Subject: AEC Docket 50-305
Kewaunee Nuclear Power Plant
Main Steam Check and Isolation Valve Analysis

REQUEST FOR ADDITIONAL INFORMATION

Report PIO-02-03, "Maximum Energy of Disc Impact, Main Steam Check and Isolation Valves for Kewaunee Unit 1", September 6, 1973.

REPORT PIO-01-06, "Structural Analyses of Main Steam Check & Isolation Valves for Prairie Island, Unit 1", September 14, 1973.

FIGURE 1: PRESSURE DROP ACROSS THE DISC VS DISC ANGULAR POSITION FOR ISOLATION VALVE ANALYSIS

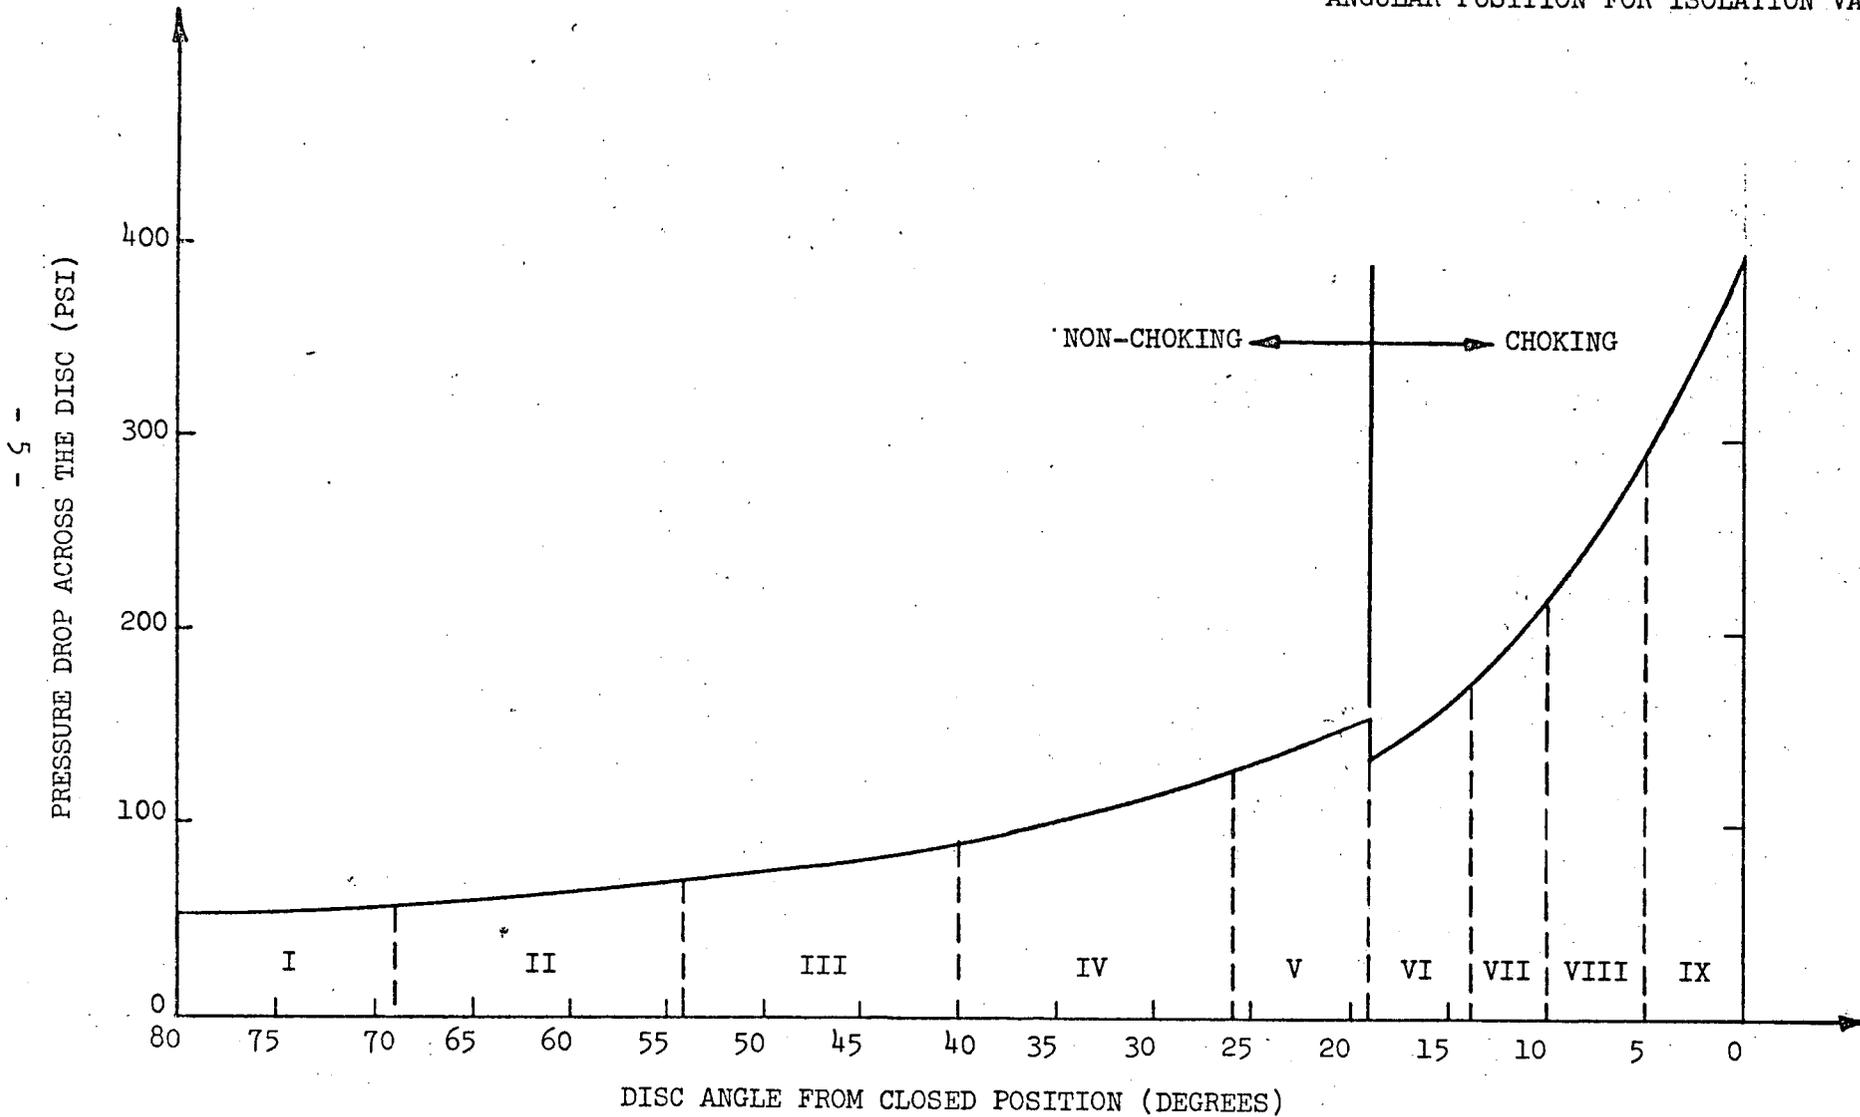
1. Rough staff calculations of the amount of impact energy due to valve closure, based on a simplified model, indicate a possible energy level as much as 30% higher than predicted in the report. To enable the staff to adequately evaluate the report:
 - a. Supplement the description on page 14 concerning the methods used to compute the pressure drop across the disc; and
 - b. Verify the flow area used for calculating the choked flow as expressed in equation (13) on page 15.

A simplified model can be used to check the results of the energy calculations. From the plot of calculated pressure drop across the disc as a function of disc angular position shown in Figure 1, attached,

<u>Area</u>	<u>ΔP_i, psi</u>	<u>θ_i, Radians</u>	<u>E_i, 10^6 in.-lb</u>
I	1/2 (55+57)	(11) $\pi/180$	0.074
II	1/2 (57+72)	(15) $\pi/180$	0.117
III	1/2 (72+92)	(14) $\pi/180$	0.138
IV	1/2 (92+127)	(14) $\pi/180$	0.185
V	1/2 (127+154)	(7) $\pi/180$	0.118
VI	1/2 (132+170)	(5) $\pi/180$	0.091
VII	1/2 (170+218)	(4) $\pi/180$	0.093
VIII	1/2 (218+297)	(5) $\pi/180$	0.155
IX	1/2 (297+388)	(5) $\pi/180$	0.206

$$\text{Total Impact Energy} = \sum E_i = 1.177 \times 10^6 \text{ in.-lb}$$

This result compares very well with the calculated value of 1.162×10^6 in-lb. given in Table 6-2 of Report PI0-02-03.

FIGURE 3

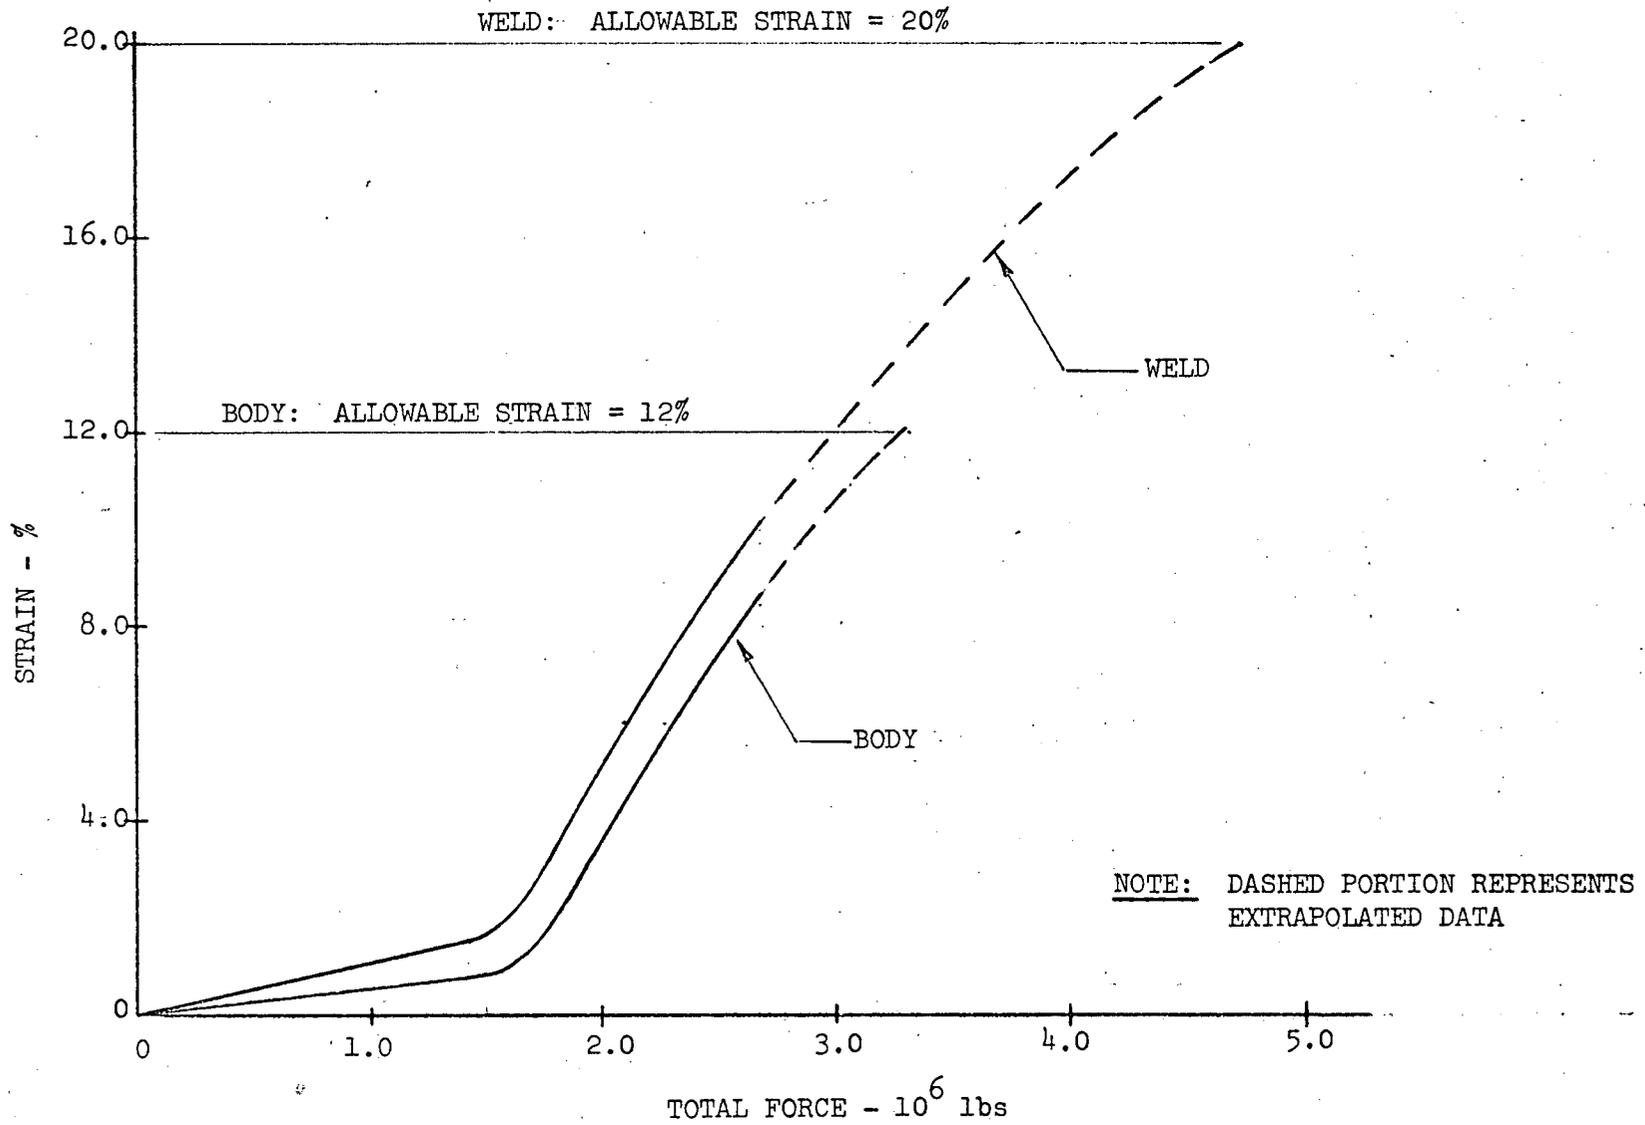
2. Table 6-1, page 20, indicated that the valve body and valve seat weld will experience a significant amount of local plastic strain due to spurious valve closure. Such deformation may introduce a certain amount of configuration change and a loss of material ductility. Provide additional information to demonstrate that after the assumed three spurious closures, the seat body of the isolation valve will still meet the initial design criteria and perform the intended safety function.

To establish a value for the available strain energy of the two valve seat components, body and weld, the force-deflection conditions at maximum allowable strain levels must be determined from the analyses provided in Report PIO-01-06. However, as the allowable strains of 12 and 20 percent (Table 6-2) occur at loads which are beyond the range of the available analyses, it is necessary to extrapolate the data to the points of allowable strain. By employing an extrapolation of the curves shown in Figures A.2-2 and A.2-3 of Report PIO-01-06, the available strain energies associated with

the allowable strains are found to be 0.192×10^6 in-lb. and 0.440×10^6 in-lb. for the body and weld respectively. These extrapolated curves are shown in Figures 3 and 4 attached. Upon comparing these energy values, it is apparent that the valve body is the critical component for establishing the spurious trip limit.
